Product Change Notification

Product Change Notification: E-19-012949**PCN Date:** 22-AUG-19**Customer:** Mouser Electronics Inc (167836)**Location:** Mansfield**Agreement:** Agreement Unknown

DEUTSCH HDP20 Series, Plug and Receptacle Assemblies Packaging Change

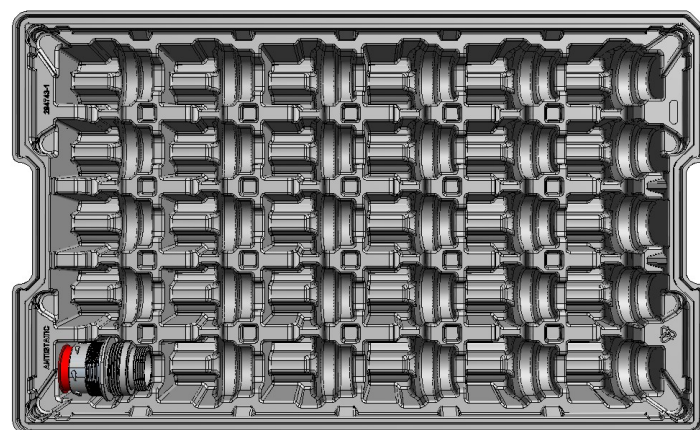
The Industrial and Commercial Transportation business unit of TE Connectivity is changing the packaging to use standard automotive AIAG shape and size packaging for the part number(s) listed below. New packaging dimension LxWxH is 21.9375 in x 13.5625 in x 11.475 in. Standard Package Quantity will change from pack counts as indicated below. Receptacle pack counts per modification will change as follows: L017 from 160 to 150, L015 from 120 to 150. Receptacle pack counts per modification will stay the same as follows: L024 from 200 to 200, Standard from 200 to 200. Plug pack counts per modification will change as follows: L015 from 160 to 200. Plug pack counts per modification will stay the same as follows: L017 from 200 to 200, L024 from 200 to 200, Standard from 200 to 200. Product drawings are not affected. These PN's are TE proprietary designs, therefore considered catalog product. PPAPs will not be submitted for this change since product fit, form and function is not affected.
